Intel[®] 815EP Chipset Platform for Use with Universal Socket 370

Design Guide Update

April 2002

Document Number: 298602-003

5. Changed Figure 79, RTC Power Well Isolation Control, in Section 10.8.6, Power Well Isolation Control Strap Requirements

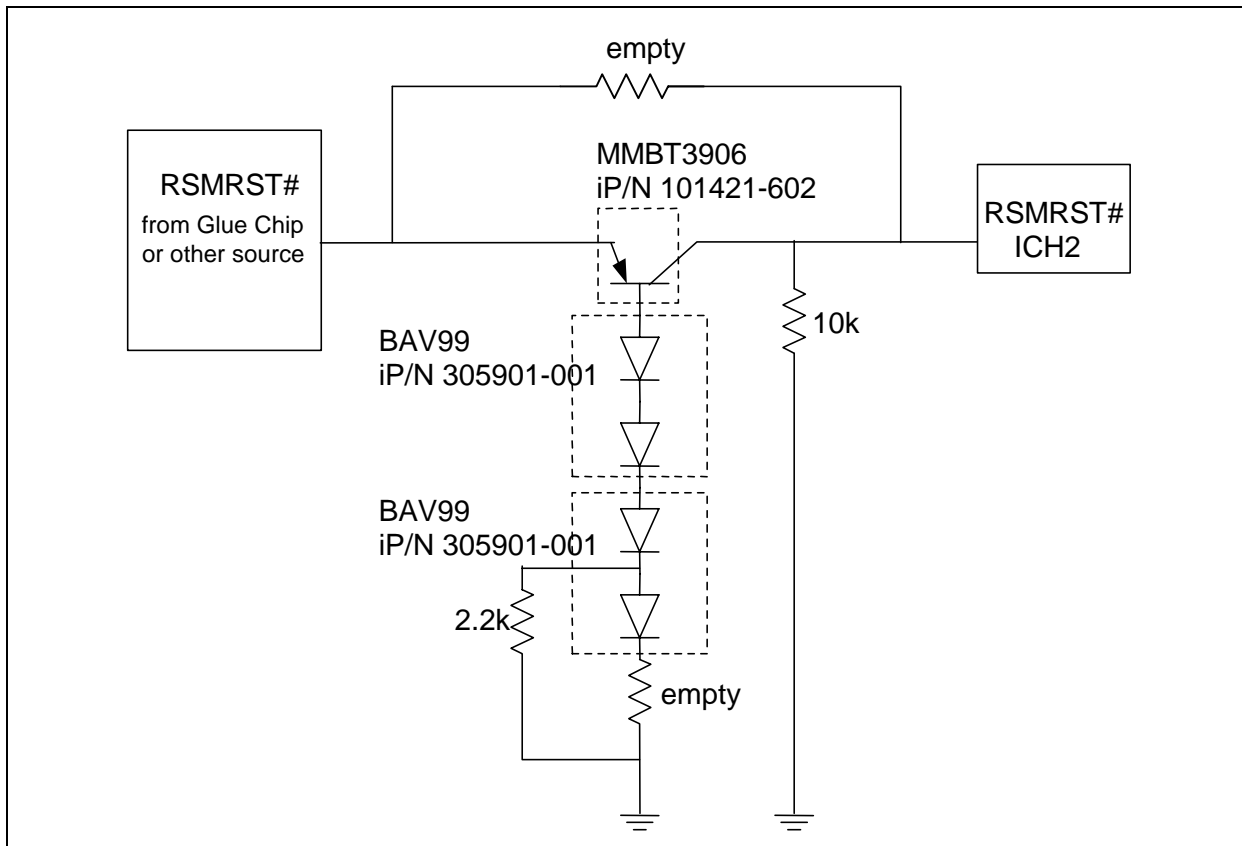
Figure 79, RTC Power Well Isolation Control, is changed to the following:

9. **Changed Figure 98, Power Delivery Map, in Section 12, Power Delivery**

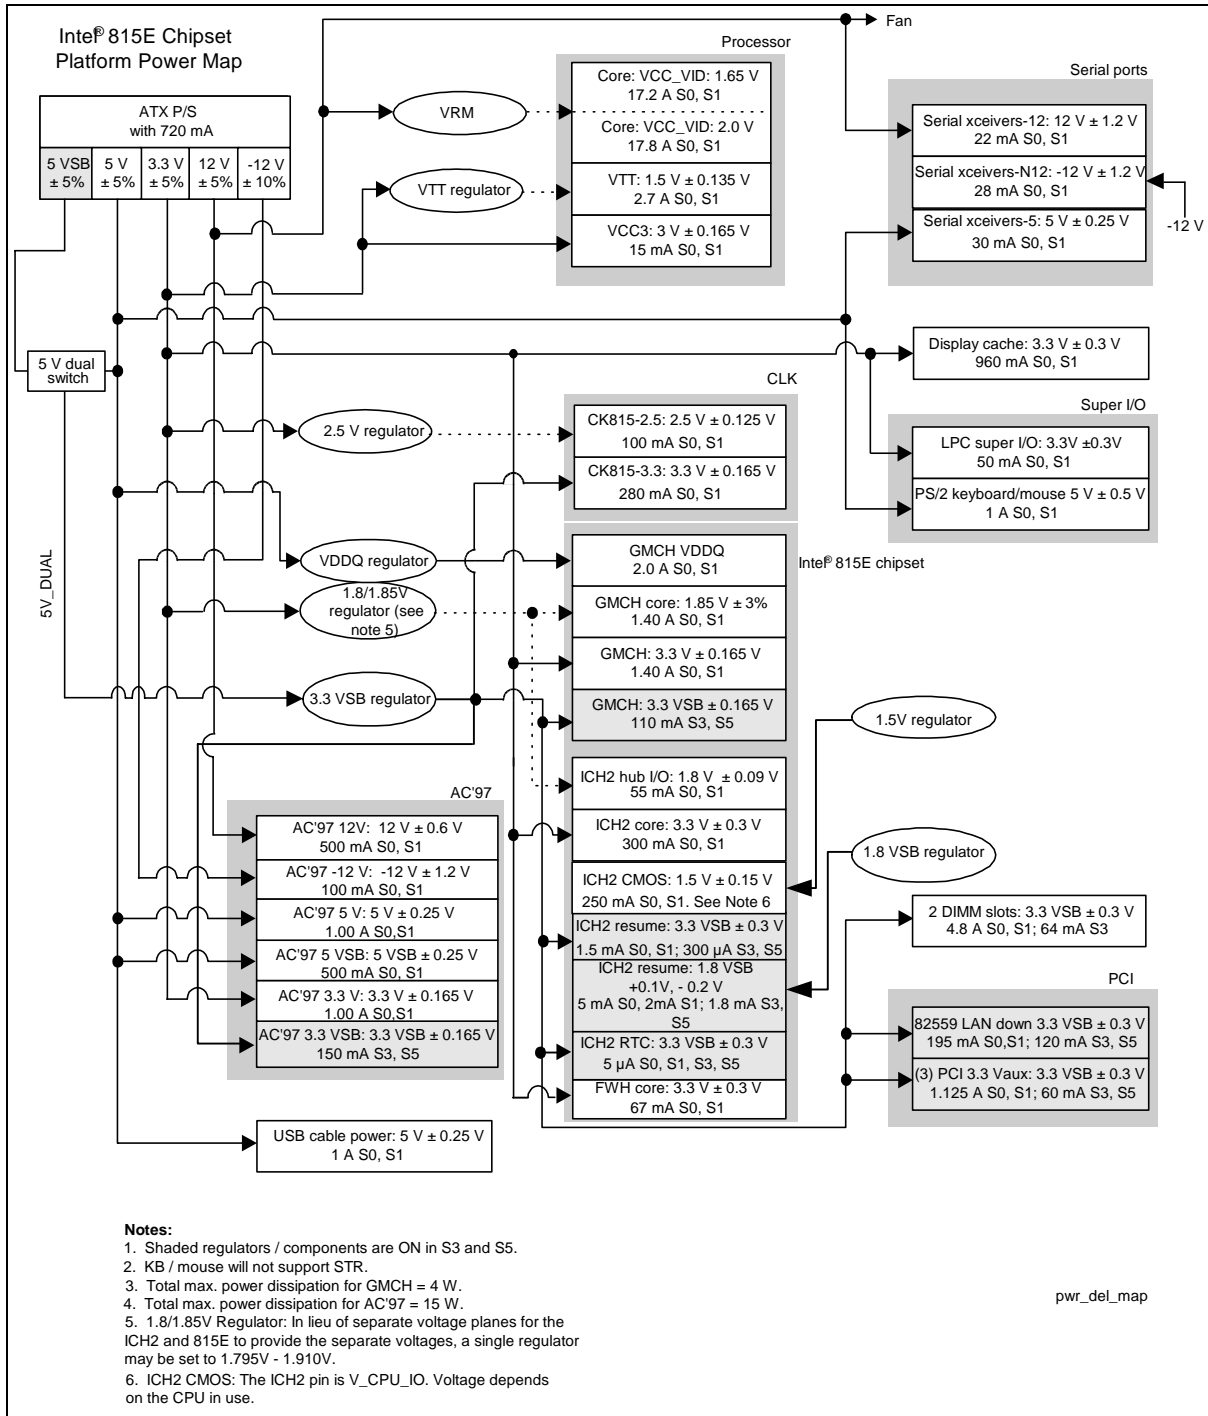
Figure 98, *Power Delivery Map*, in Section 12, *Power Delivery*, has two changes in the ICH2 section.

1. An ICH2 power plane is added to it. This added ICH2 power plane is “ICH2 CMOS”. This power plane has always existed in the ICH2. It is not new. This addition to the Power Delivery Map simply shows this ICH2 plane.
2. An ICH2 power plane is added to it. This added ICH2 power plane is “ICH2 Resume 1.8 VSB”. This power plane has always existed in the ICH2. It is not new. This addition to the Power Delivery Map simply shows this ICH2 plane.

Figure 100, *Power Delivery Map*, is replaced with the following:

Figure 1 Top Signal Layer before the Ground Fill Near the I/O Layer

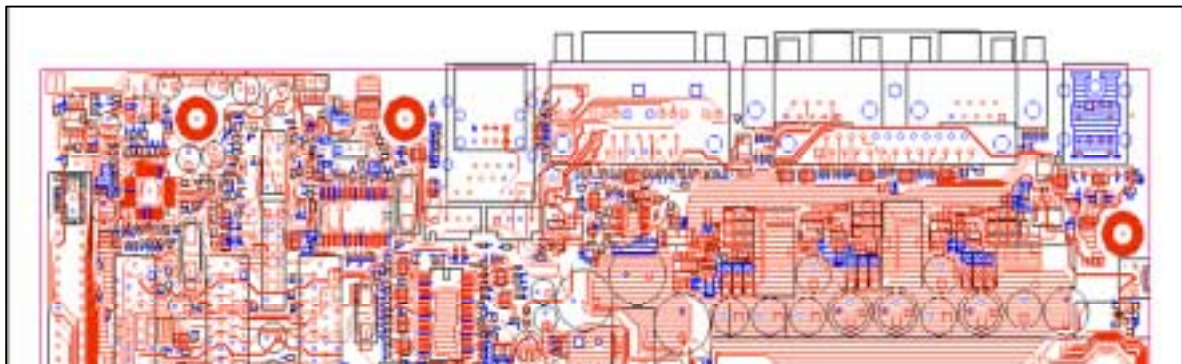
Intel recommends that the I/O area on the top and bottom signal layers of a 4-layer motherboard near the I/O back panel be filled with a ground fill as shown in Figures 1-4. In addition, a ground fill cutout should be placed on the Vcc layer in the area where the ground fill is done on the top and bottom layers. Intel recommends filling the I/O area as much as possible without effecting the signal routing. The board designer should fill the entire I/O area along the board edge.

The spacing from the ground fill to other shapes/traces should be at least 20 mils. It is recommended that these ground fill areas be connected to two chassis mounting holes (as seen in Figure 2). This will allow ESD current to travel to the chassis instead of the board. Ground stitching vias should be placed throughout the entire ground fill if possible. It is important that the vias are placed along the board edge. Ground stitching vias for the ground fill should be 100-150 mils apart or less.

1. Fill the I/O area with the ground fill in all layers including signal layers whenever possible
2. Extend the ground fill along the entire back I/O area
3. Connect the ground fill to mounting holes
4. Place stitching vias 100-150 mils apart in the entire ground fill
